## RM240156 – RESPONSE TO LANDSCAPE REQUEST FOR FURTHER INFORMATION

1. This memo responds to landscape-related questions of a Request for Further Information (RFI) in relation to RM240156. These questions were set out in an email from Liz Hislop of Queenstown Lakes District Council dated 12 April 2024. The questions are set out in bold below, with responses given to each.

<b>OUR REFERENCE</b>	X4176
<b>DATE</b>	March 2024
<b>LOCATION</b>	83D Black Peak Road, Wānaka
<b>LEGAL DESCRIPTION</b>	Lot 4 DP 385106 contained in Record of Title 340975
<b>APPLICANT</b>	Thomas William Evatt, Rafe Ian MacLean and Michelle Louise Mitchell
<b>TERRITORIAL AUTHORITY</b>	Queenstown Lakes District Council
<b>ZONING</b>	Operative District Plan: Rural General Proposed District Plan: Rural
<b>NATURAL HAZARDS</b>	Liquefaction Susceptibility LIC 1(P)(2012) ORC Flooding (2021) Rainfall Flooding (2012)
<b>OVERLAYS</b>	Landscape Priority Area Cardrona River/Mt Barker Road
<b>ACTIVITY CATEGORY</b>	Operative District Plan – Discretionary Proposed District Plan – Discretionary Resource Management Act 1991 - Discretionary
<b>PROPOSAL</b>	<p>Application under Section 88 of the Resource Management Act 1991 (the Ac

1 00. proposed landscaping plan  
 1 : 1000  
 (IF PRINTED ON A3 SHEET)

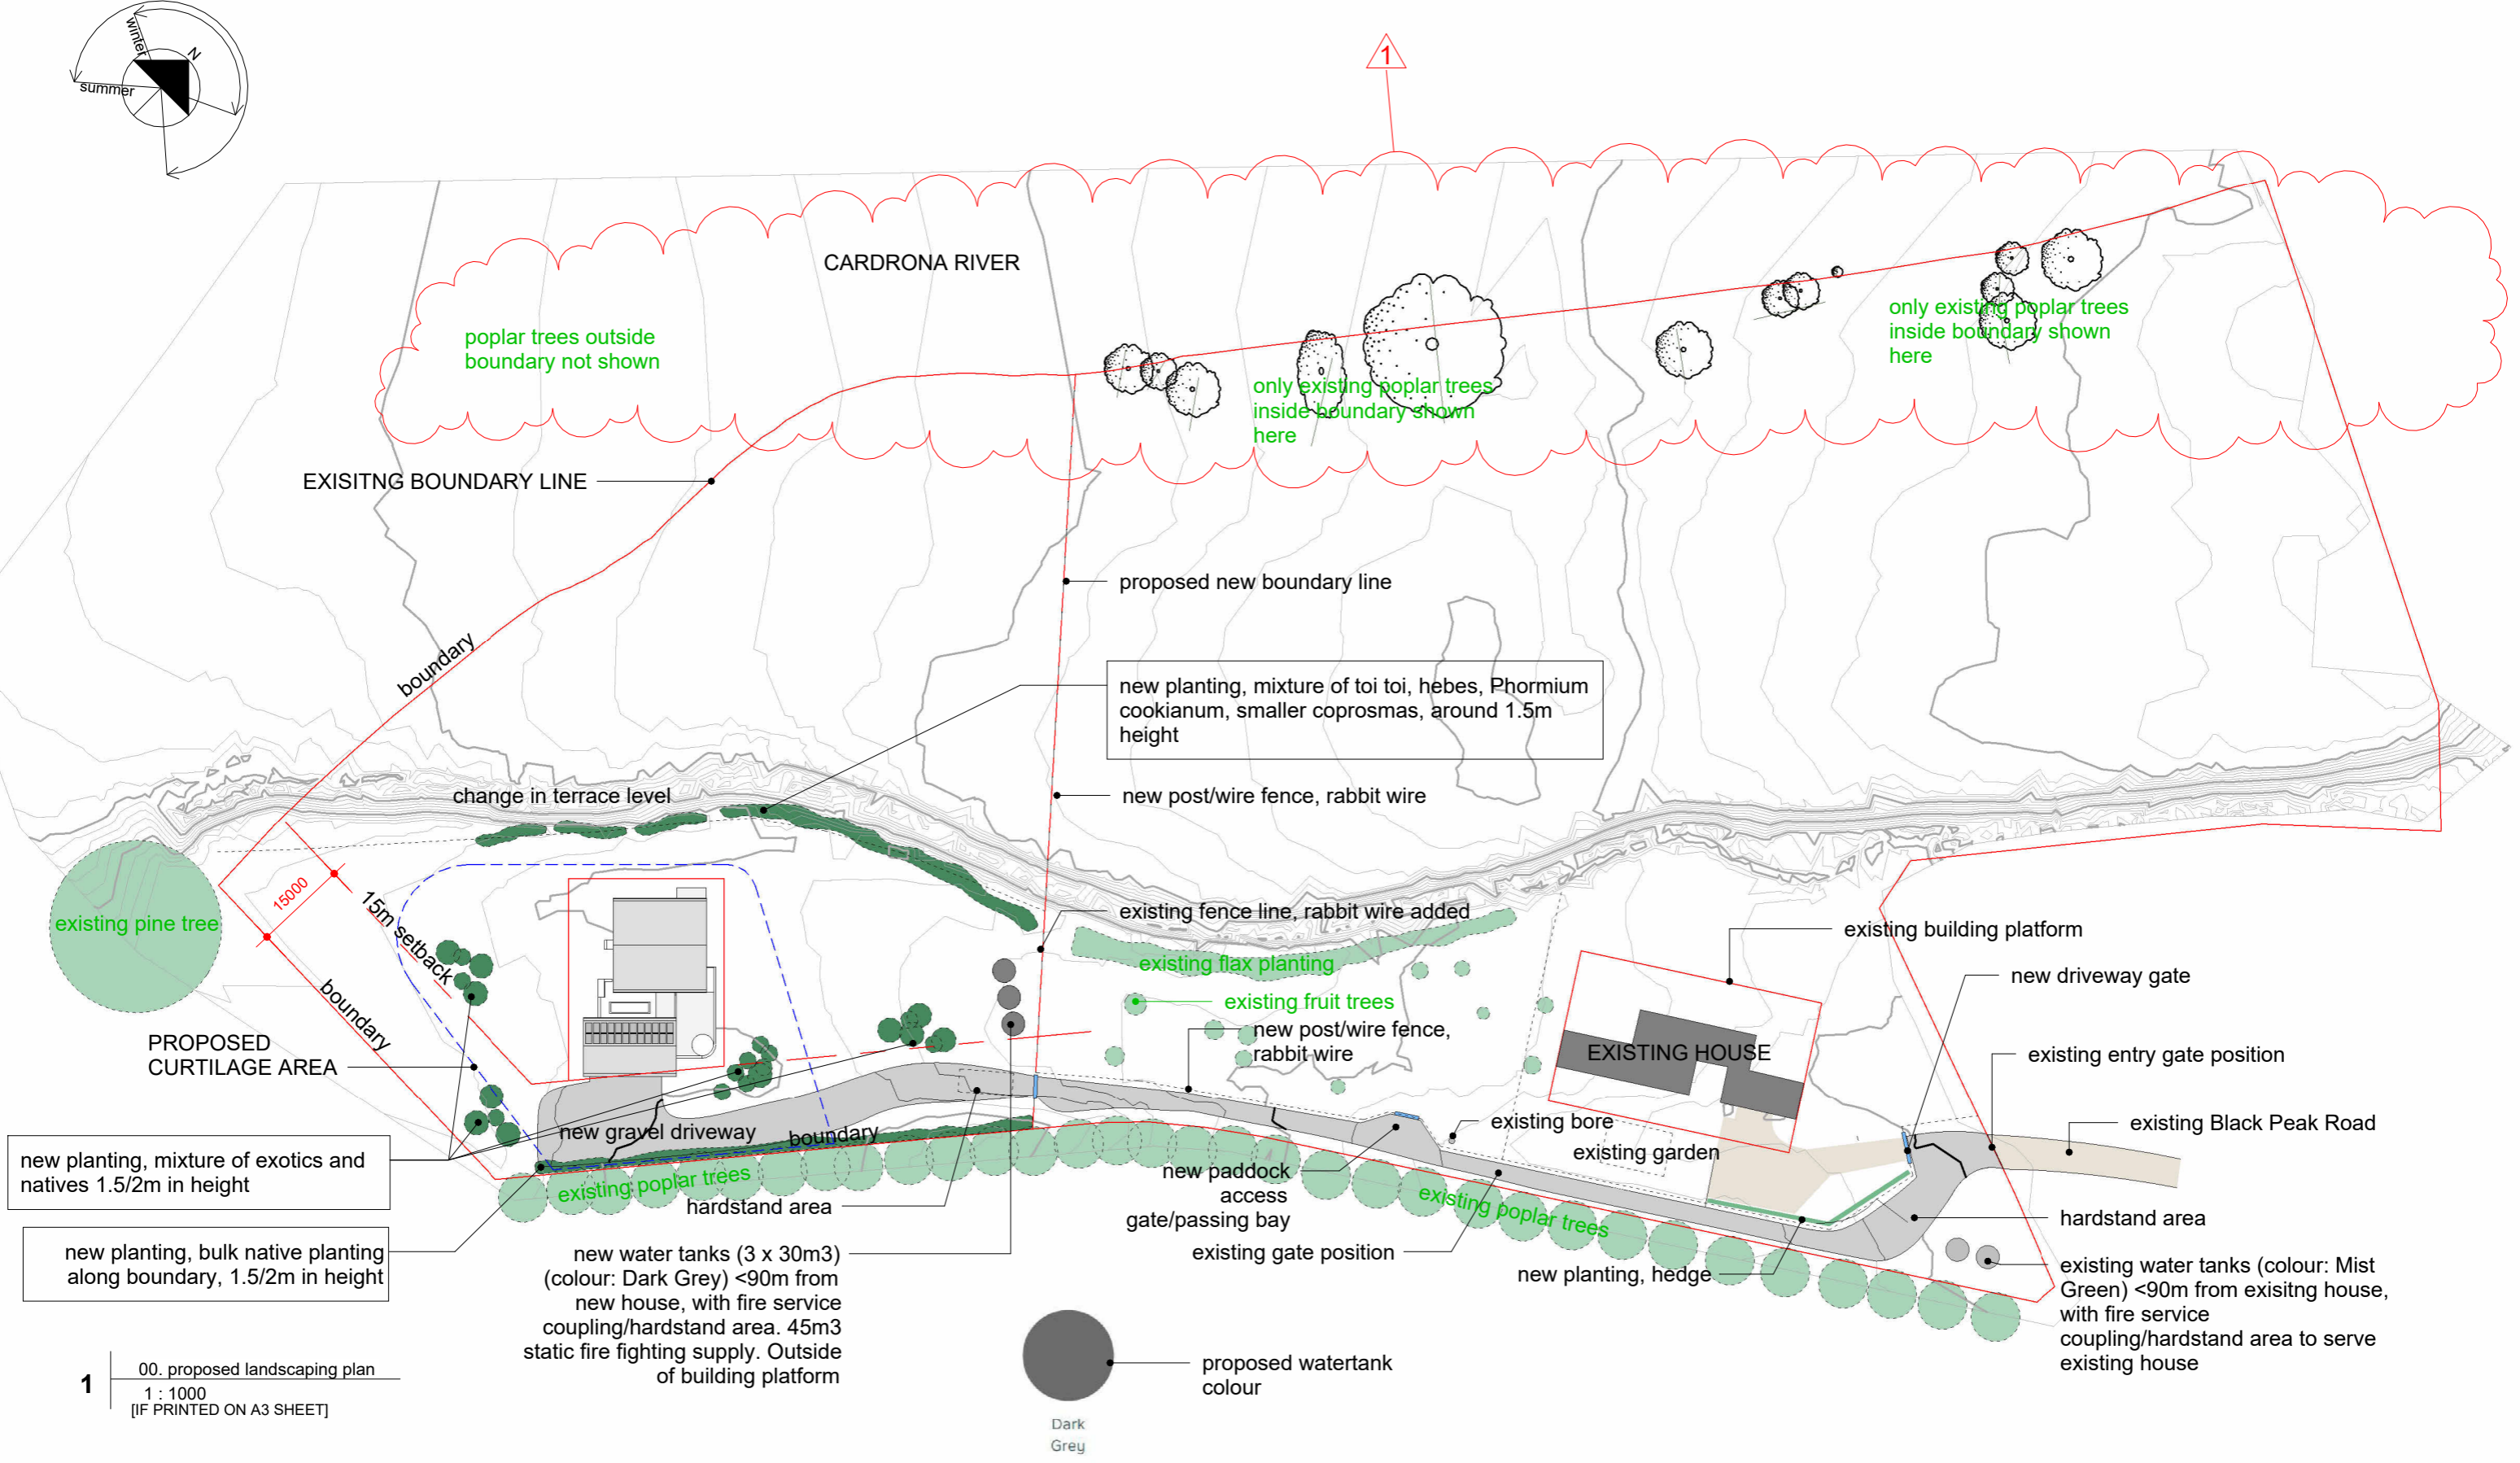
11. *Please identify/annotate on the landscape plan the poplars to be retained and check that the landscape plan accurately reflects the ones located on the site as it is not clear from the aerial image.*

Date	No.	Description
30.04.2024	1	poplar trees accurately surveyed and shown on landscape plan

Response: Please refer to updated plans attached as **Appendix ZC**.

**1** ELEVATION\_NORTHEAST  
 1 : 200  
 [IF PRINTED ON A3 SHEET]

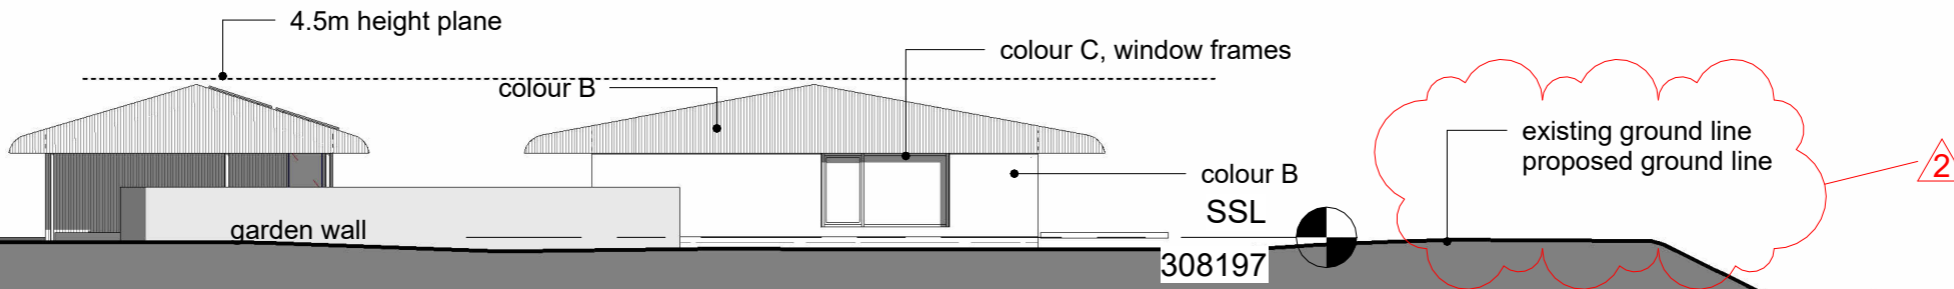
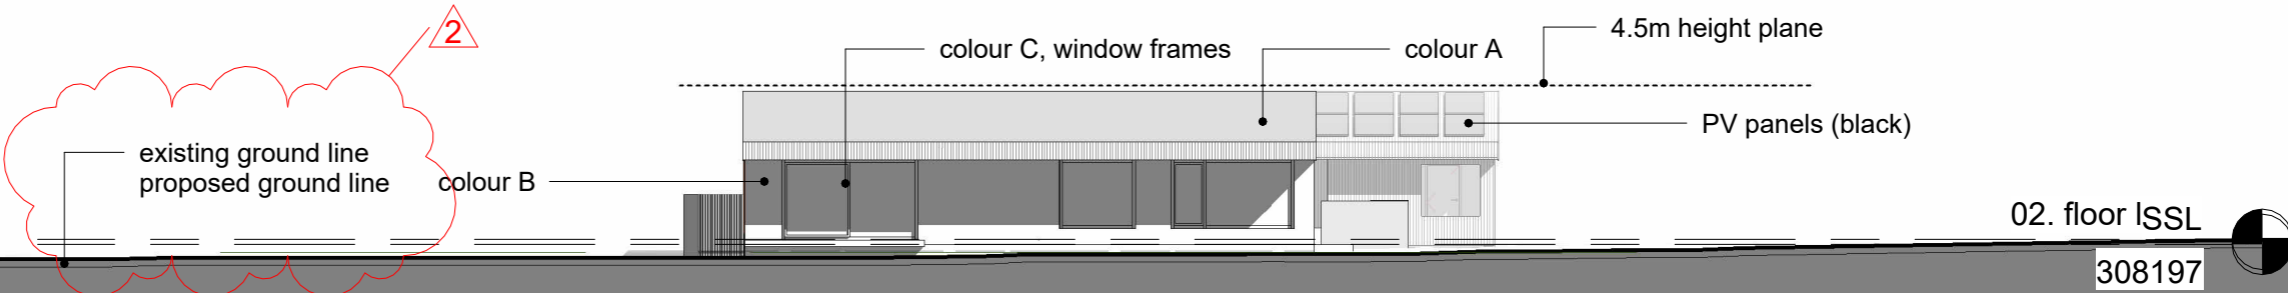
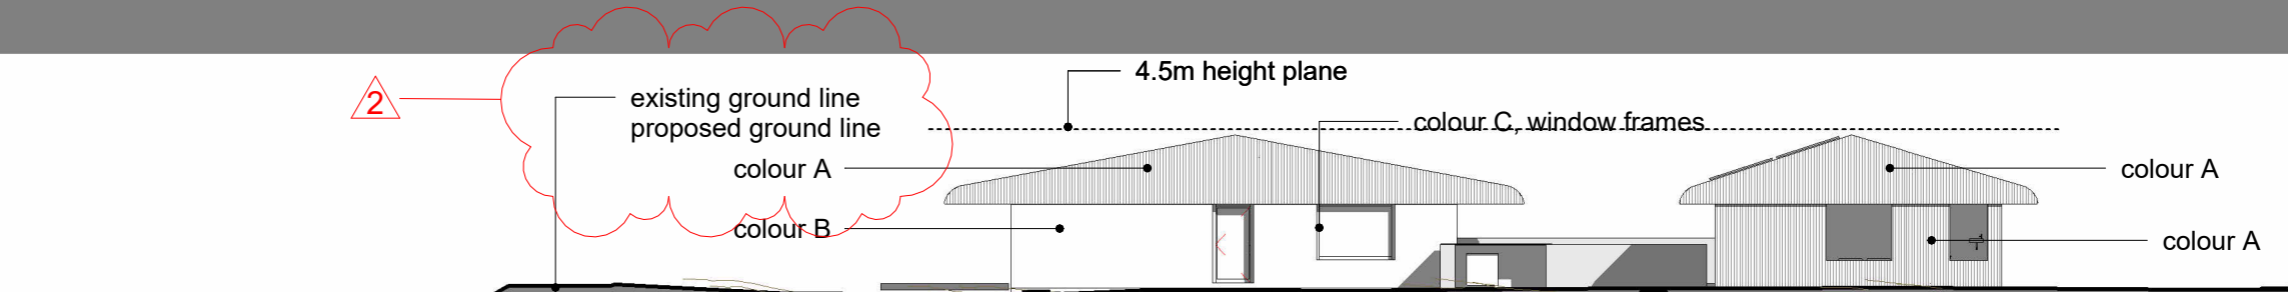
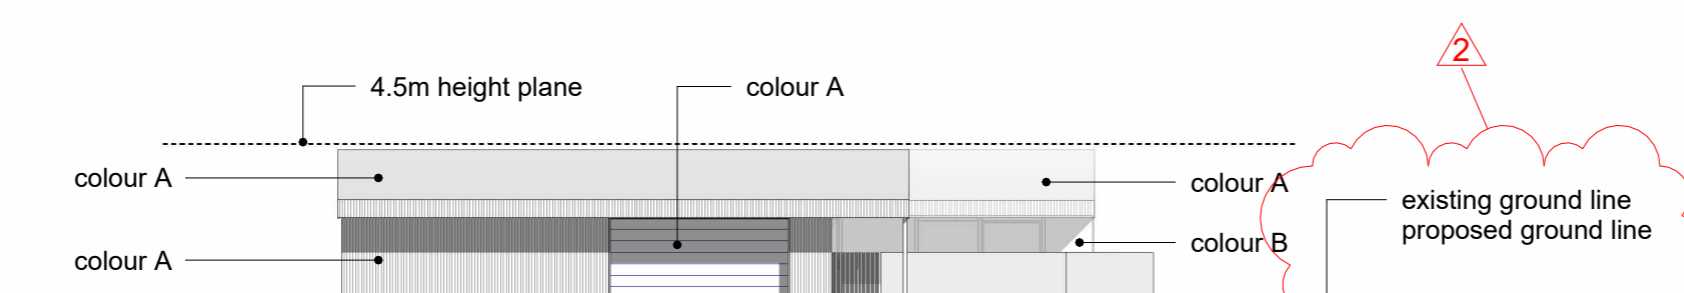
8. *Please annotate the elevation plans to show original/existing ground level and proposed ground level for clarity.*

Revision Schedule		
Date	No.	Description
30.04.2024	2	annotation added; existing & proposed ground lines

Response: Please refer to updated plans attached as **Appendix ZC**.
